Addendum #2

Attn: Estimator	Date: November 26, 2024
From: Lisa Donahue, Project Administrator	Pages: 25 (including cover page)
Re: Bullock Creek School District 2024 Bond Series 1	Project: 2025 Summer Projects HS/MS/Elem/Pine River/Floyd and Maintenance Building
CC:	Proj. #: A24907

ADDENDUM #2

Project: No. 24-120 2023 Bond – Series 1 2025 Improvements

DRAWING TITLE
EXTERIOR ELEVATIONS

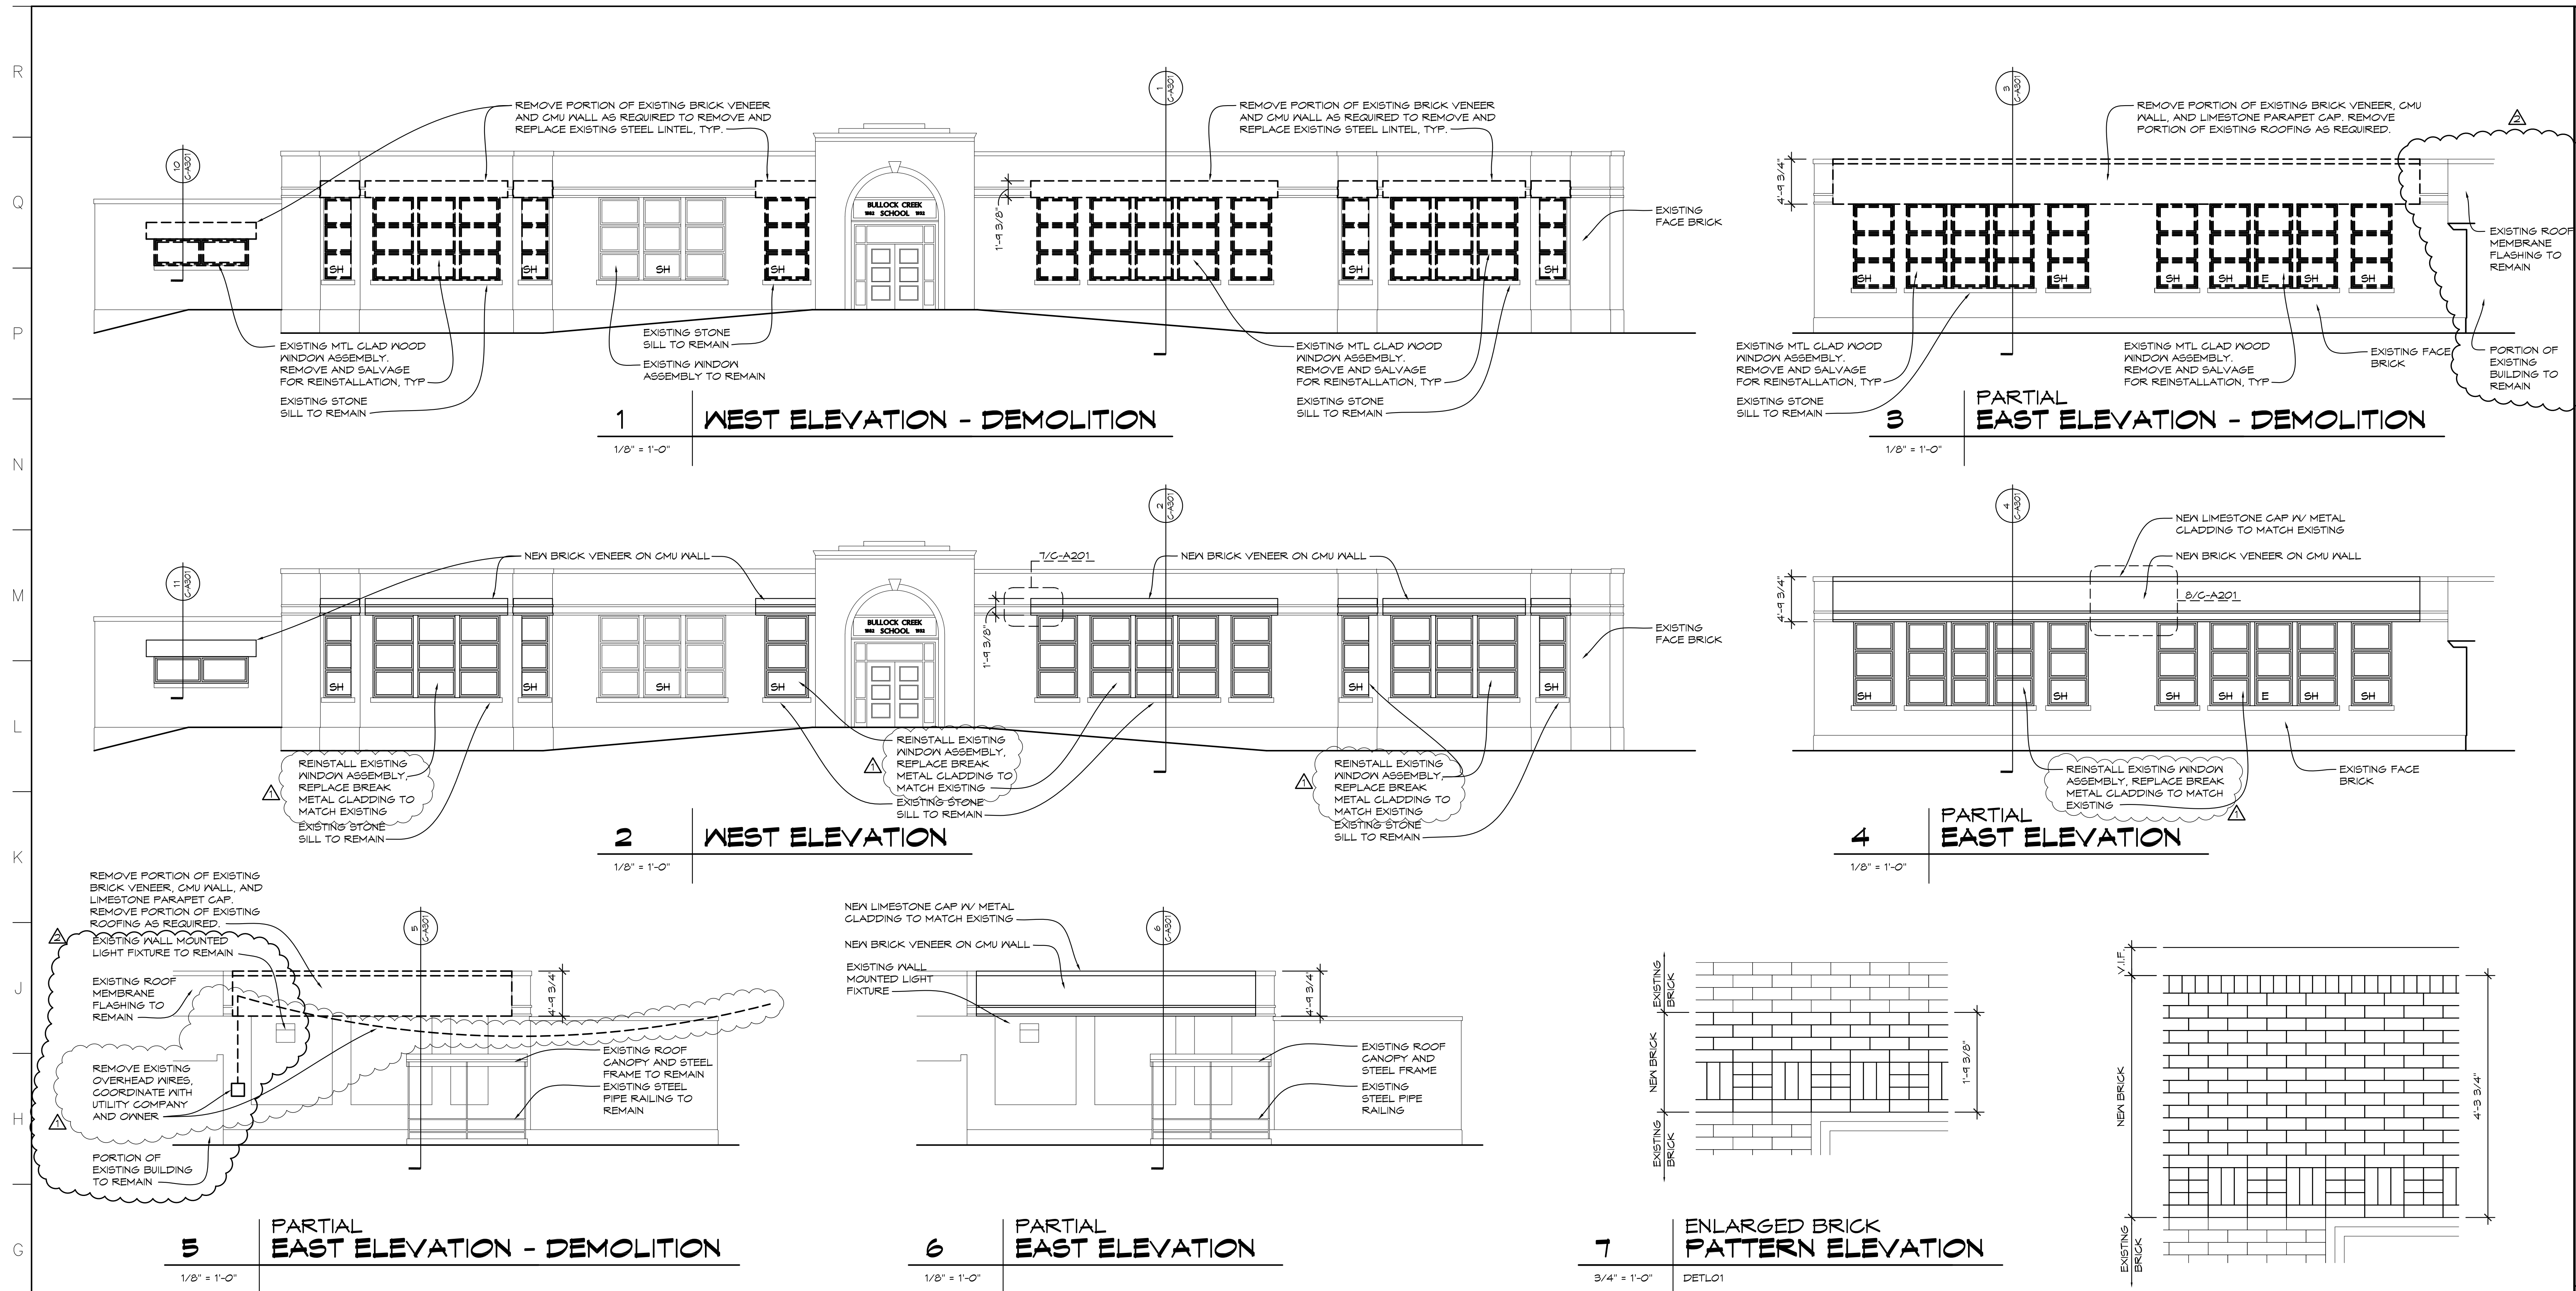
- Item #A1: Revise Sheet C-A201 as follows:
- a. Revise demolition elevations to show extent of removal of existing brick on the East side.

DRAWING TITLE:
DOOR SCHEDULE
ROOM FINISH SCHEDULE,
& DETAILS

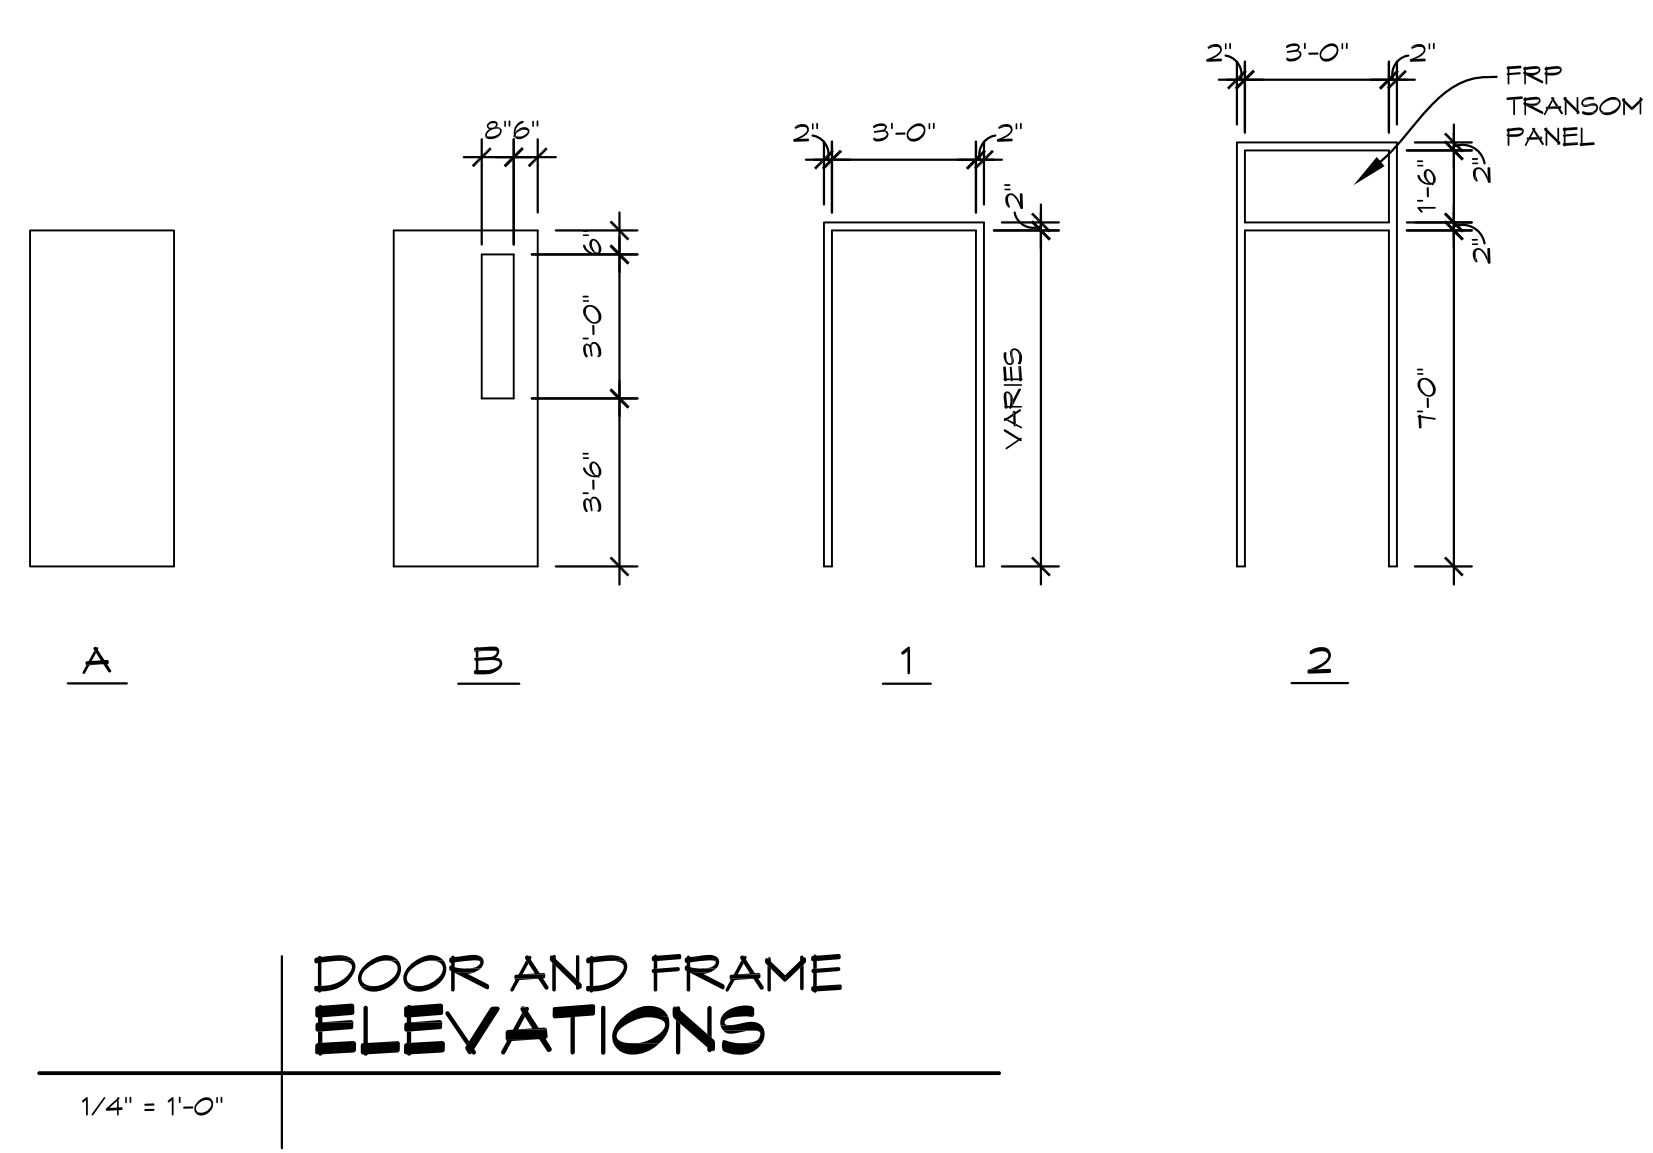
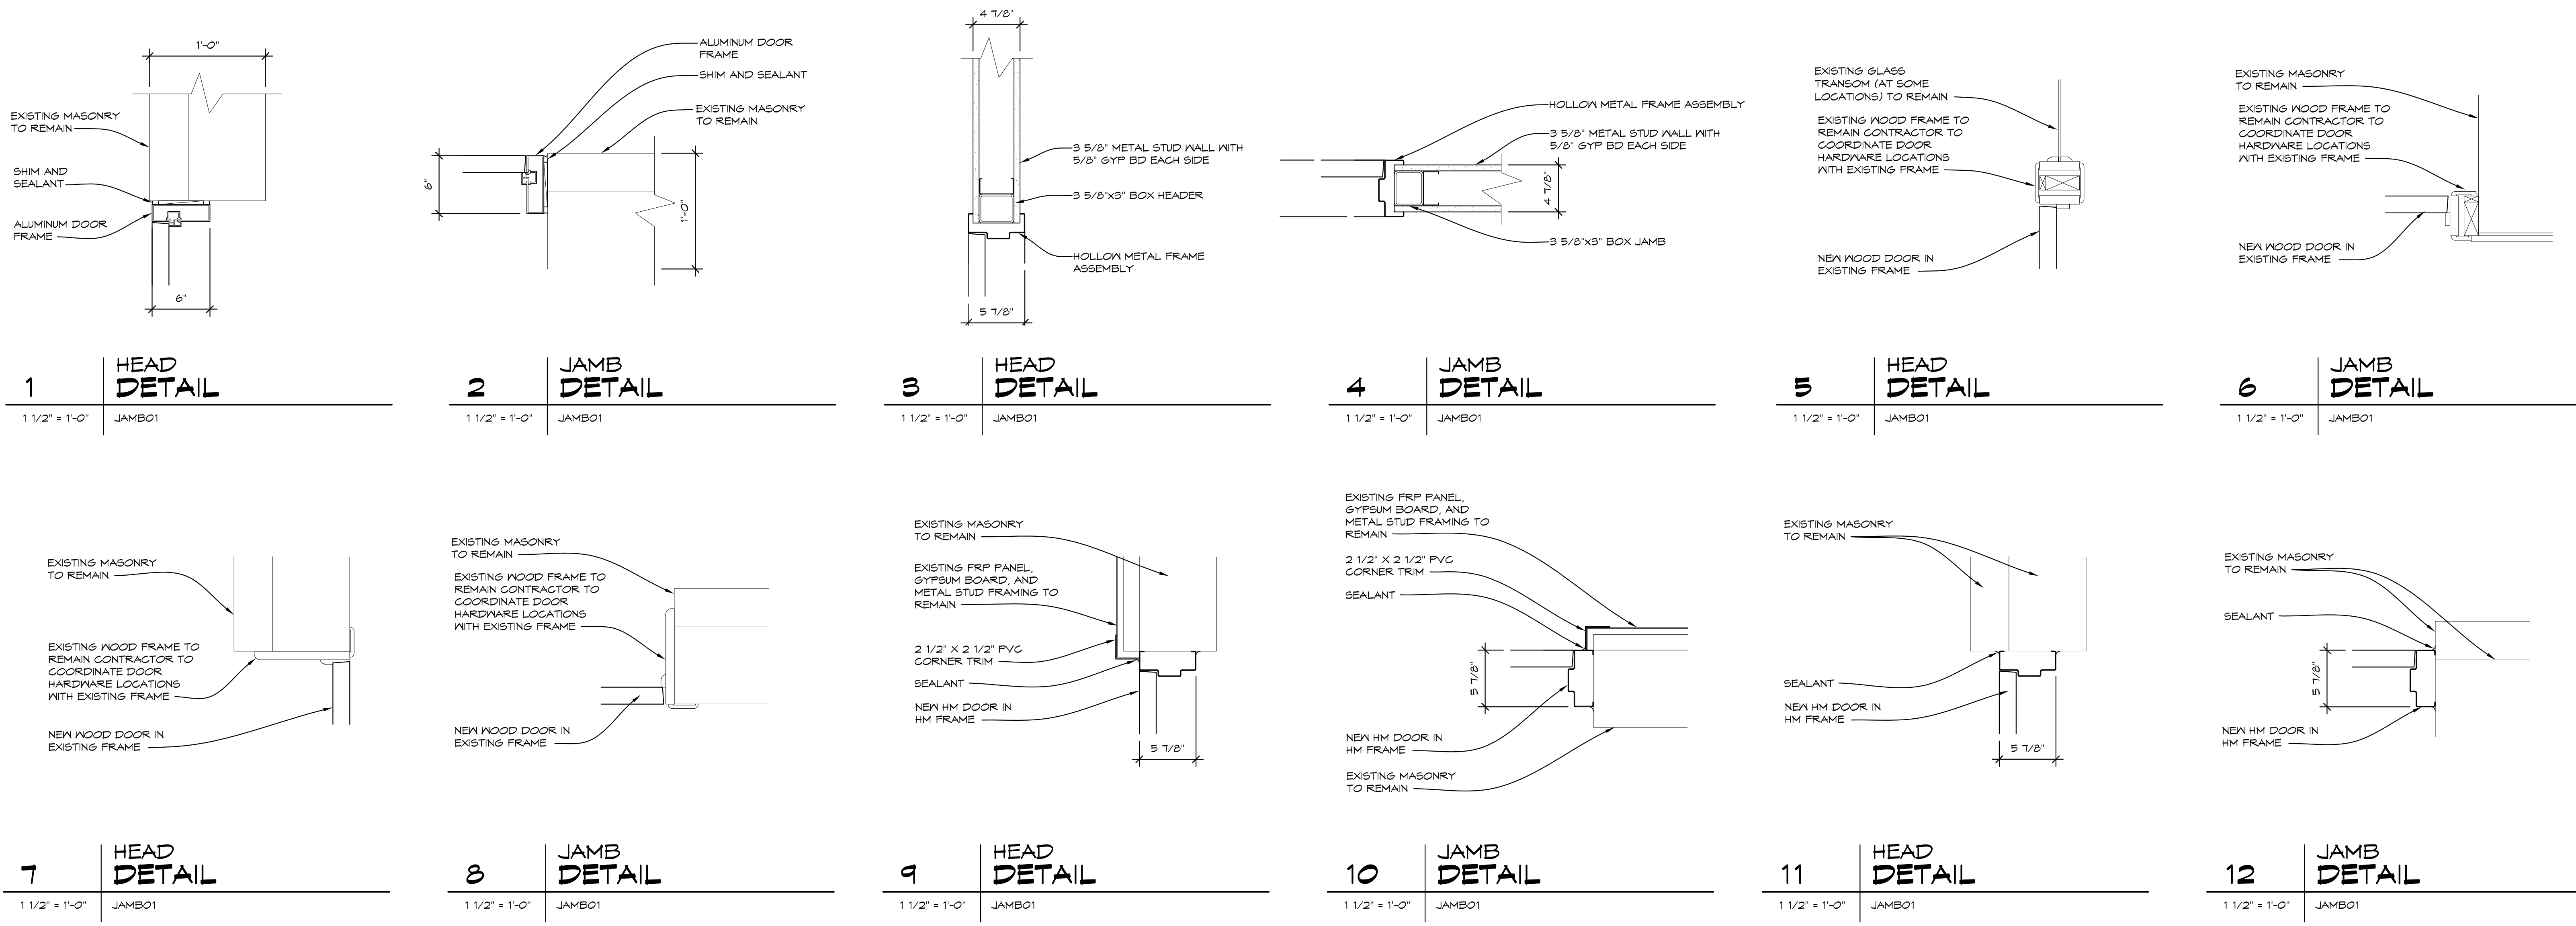
- Item #A3: Revise Sheet C-A601 as follows:
- a. Add Conference Room 101 to room finish schedule.
 - b. Revise wall base at Art Room 135 as shown.

DRAWING TITLE
ELECTRICAL ROOF PLAN

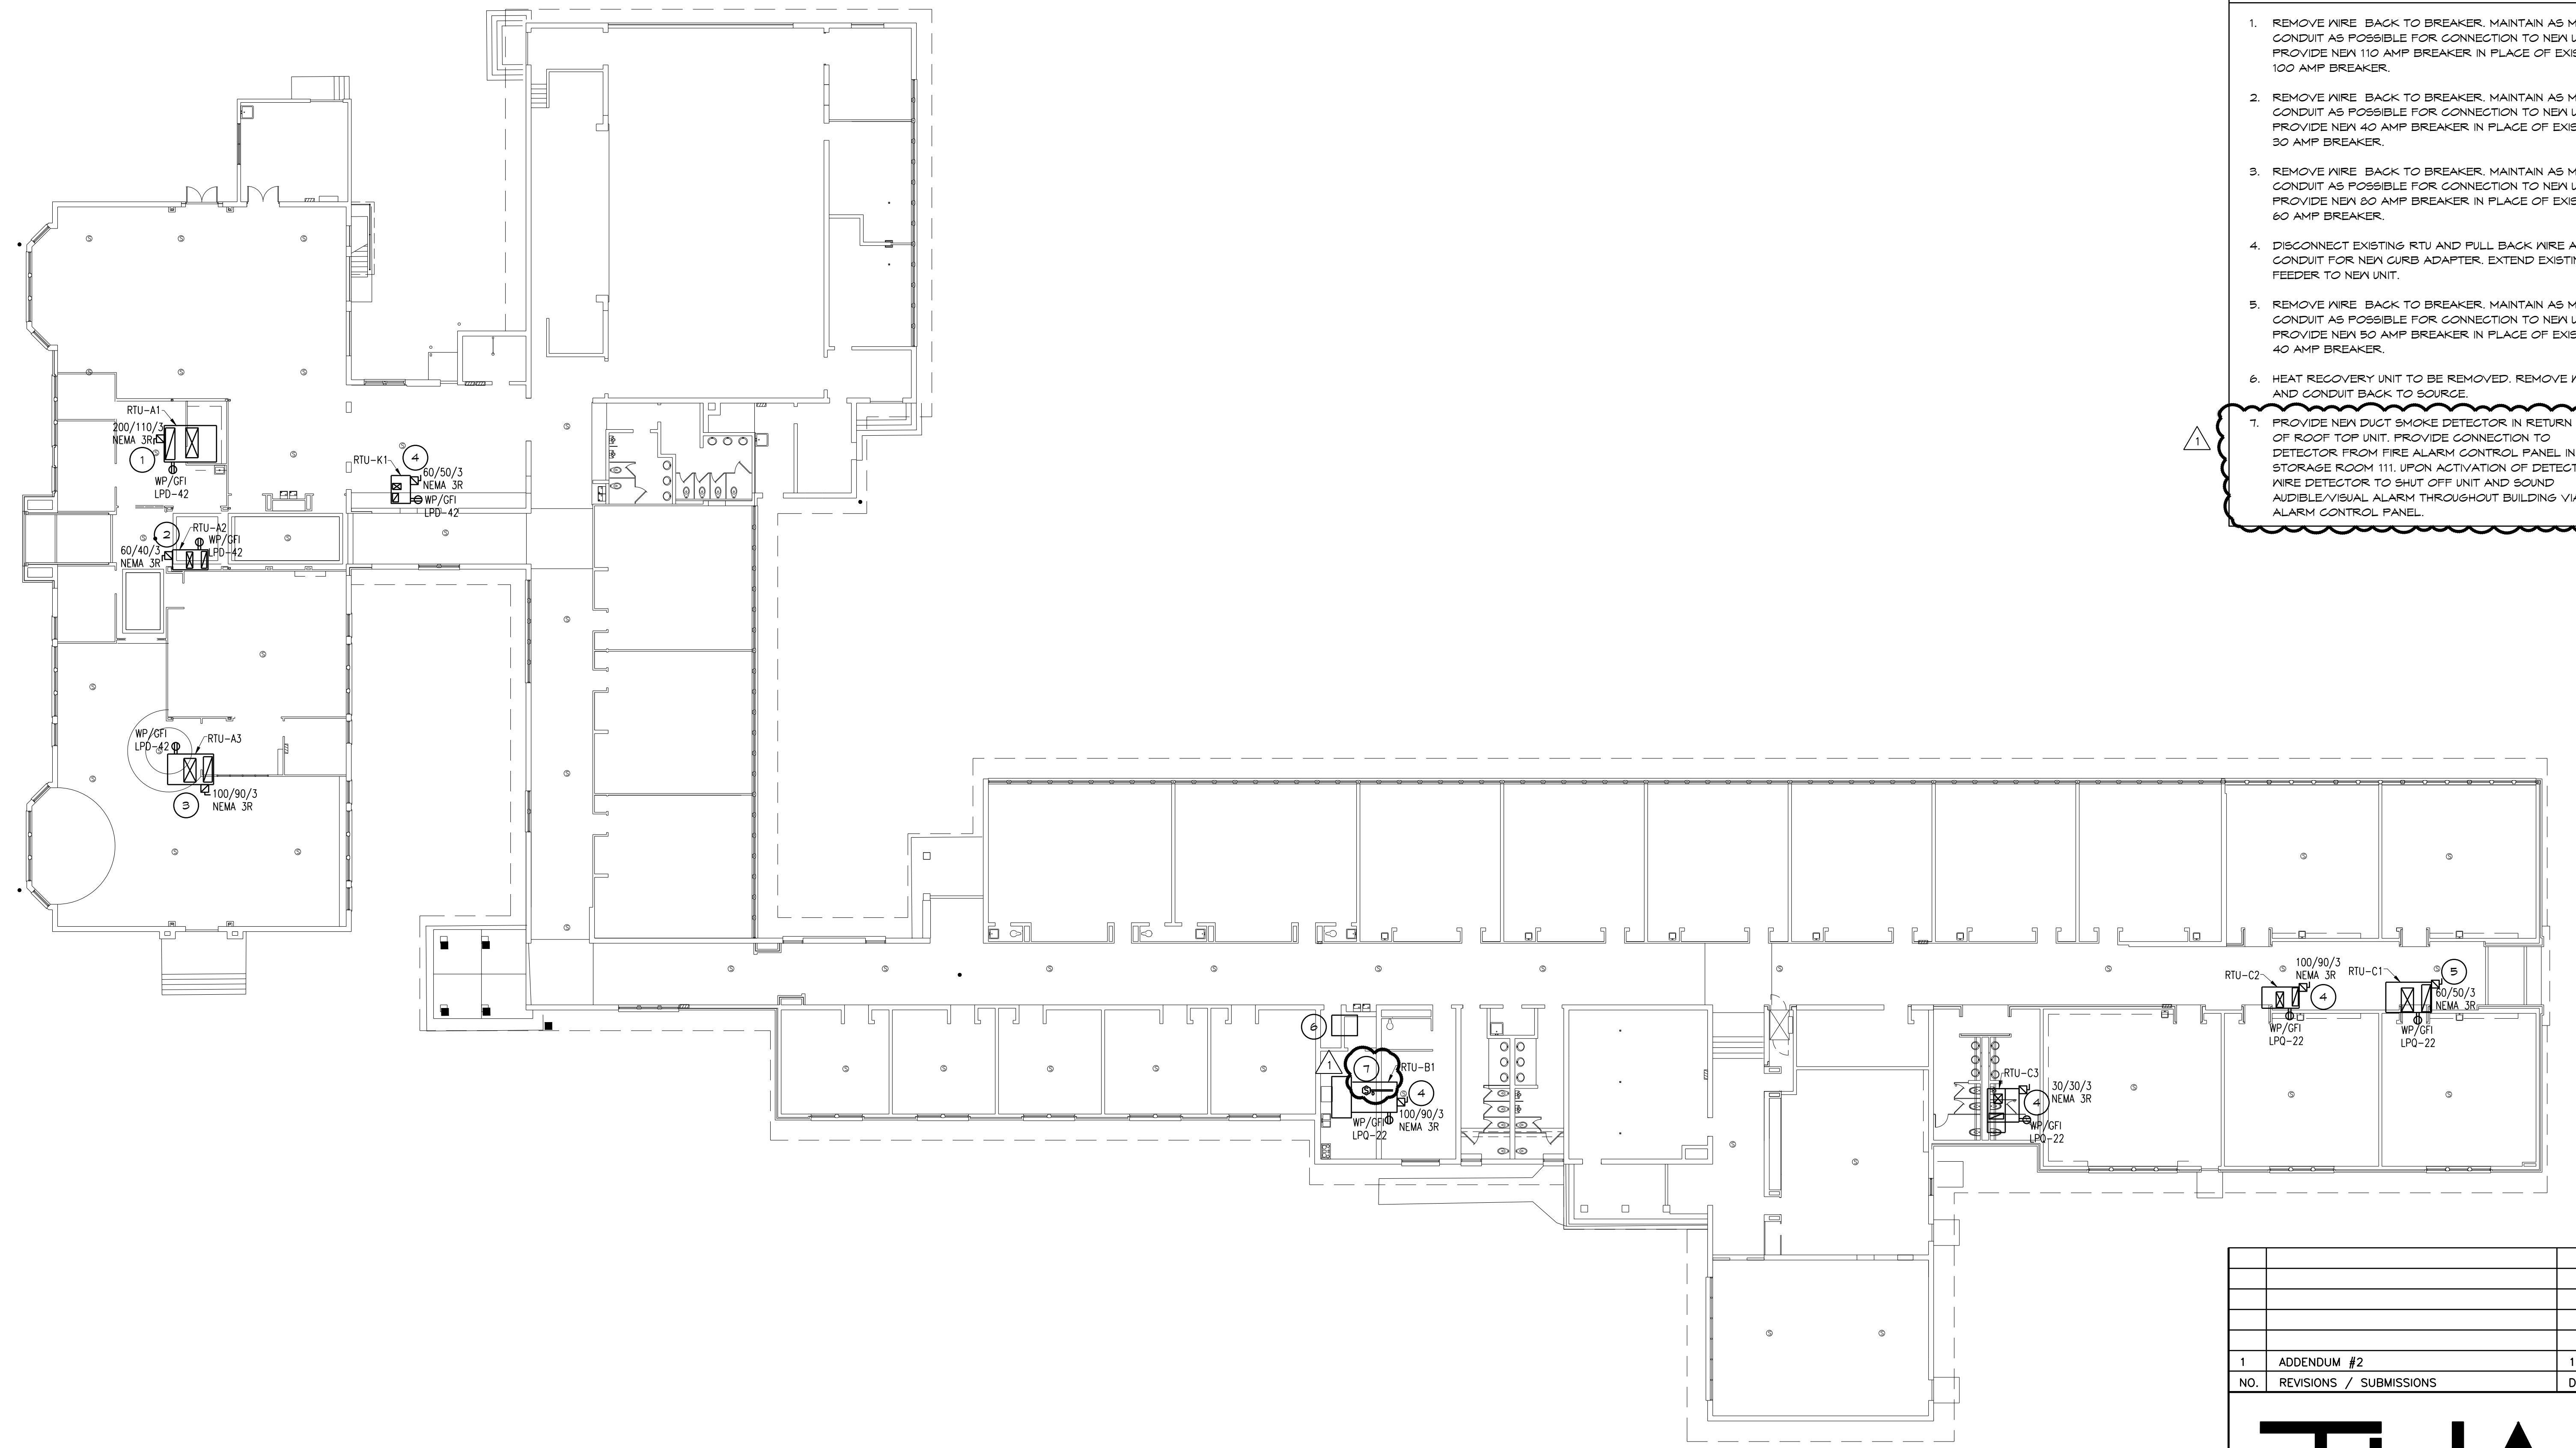
- Item #E1: Revise Sheet C-E103 as follows:
- a. Add note to provide new smoke detector in return air duct.
